Metropolitan Development Commission Regional Center Hearing Examiner (August 27, 2026) Meeting Agenda

STAFF REPORT

Case Number	2026-REG-006
Address (approx.)	219 Koehne Street, 1437 – 1533 (odd) Saulcy Street, and 1422 – 1528 (even) Astor Street
Location	Center Township, Council District #18
Petitioner	Union Holdings III, LLC, by Misha Rabinowitch
Zoning	D-8 (RC)
Request	Regional Center Approval to provide for demolition of existing dwellings and accessory structures and for construction of a multi-family residential development, consisting of approximately 241 units, an integrated parking garage with 258 spaces, and resident amenities, including a community room, a playground, dog park, and grilling area.

Schematic
Elevations - 3d
Views

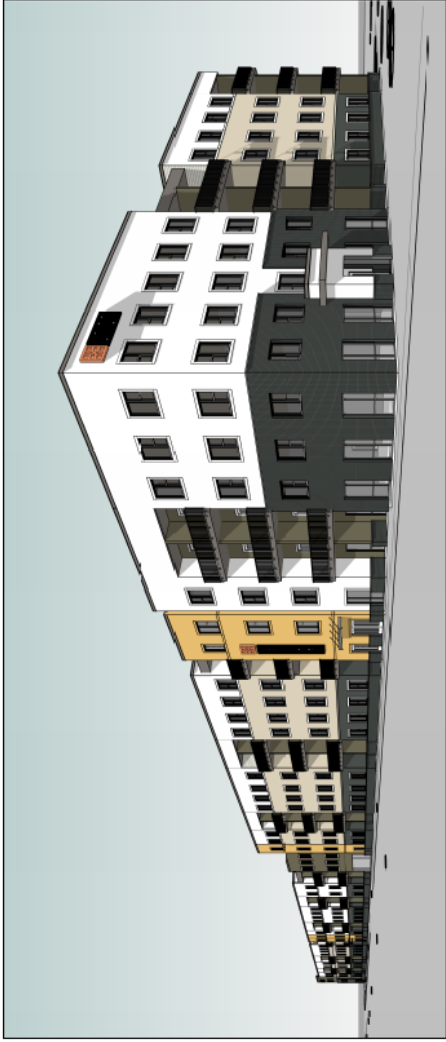
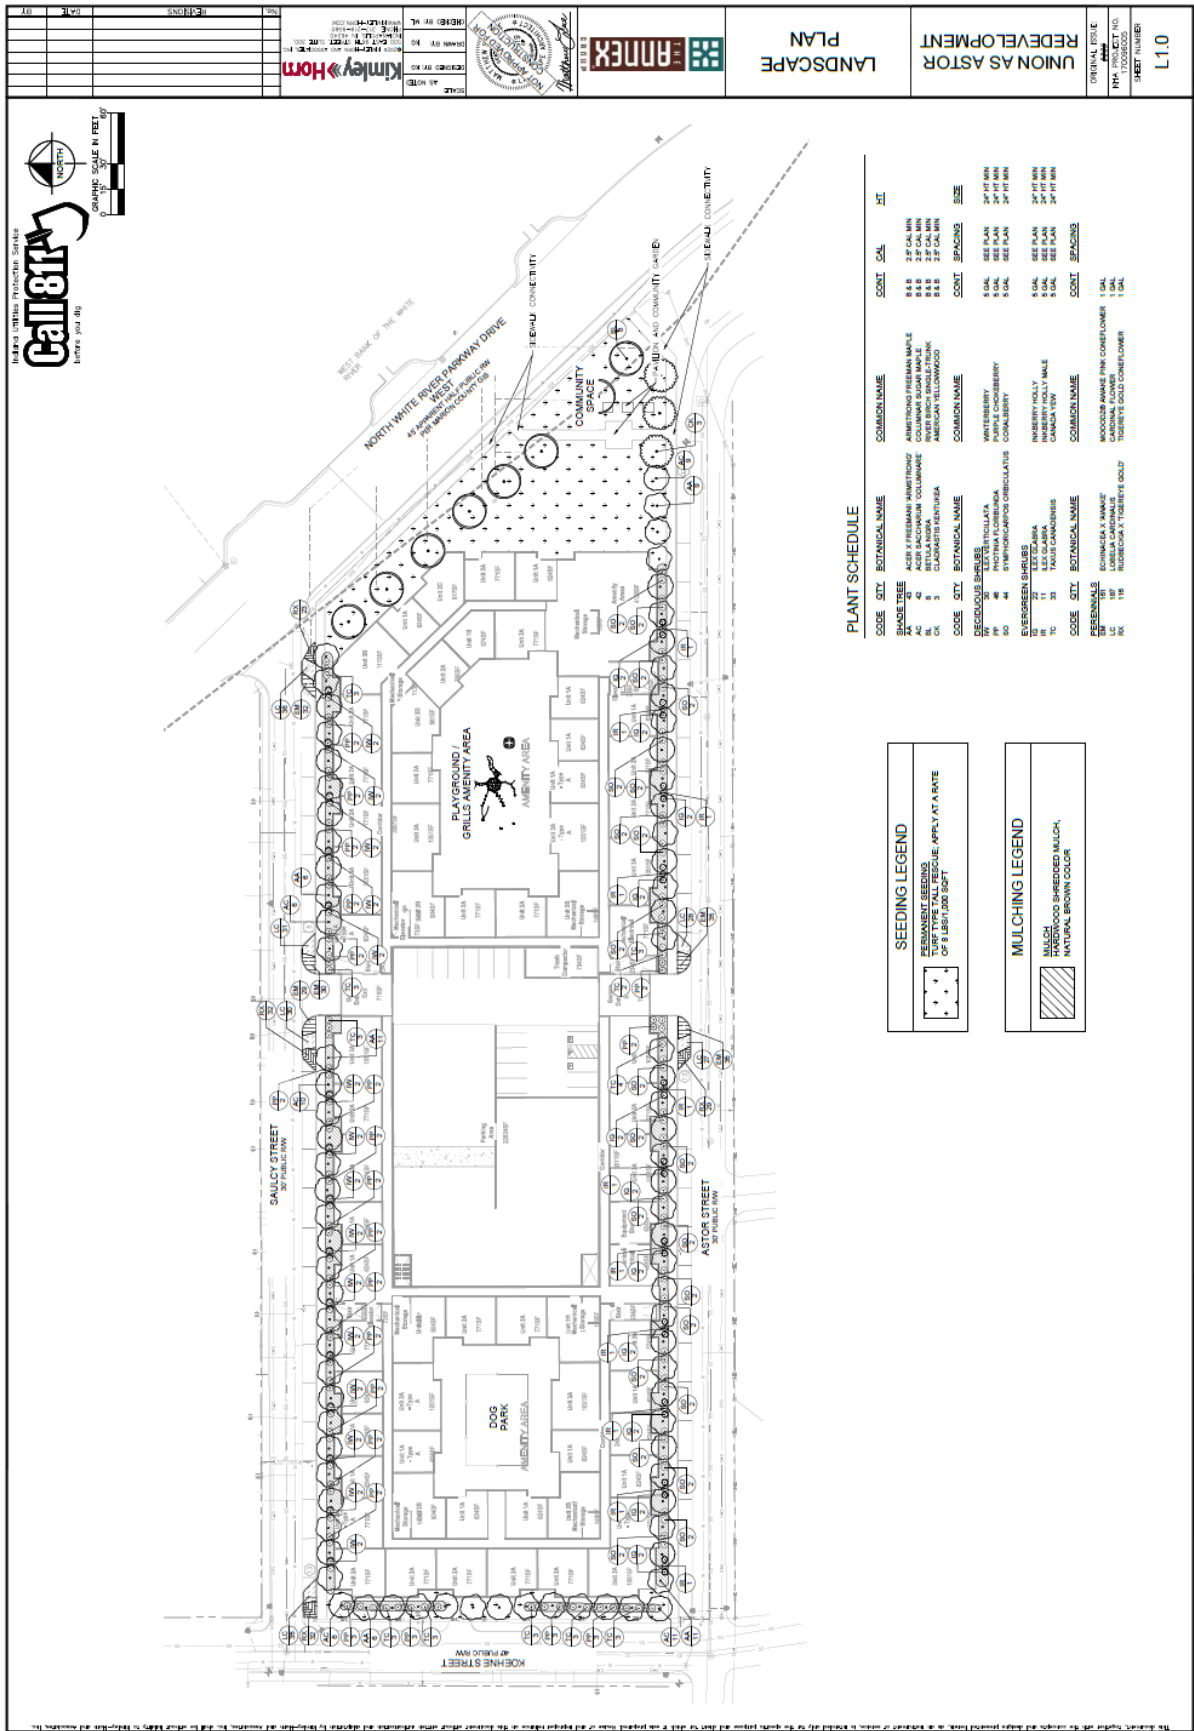
Building materials would be primarily fiber cement with a brick base, and larger sections of brick on the west façade that wraps around the building corners and at the first and second levels on south portion of the east façade and wraps around the corner.

2. The building materials is primarily made of fiber cement, a man-made material. Staff requested additional natural building material. Subsequent revised elevations note added areas of brick on the façade. Guideline CA 2.2.1 applies.
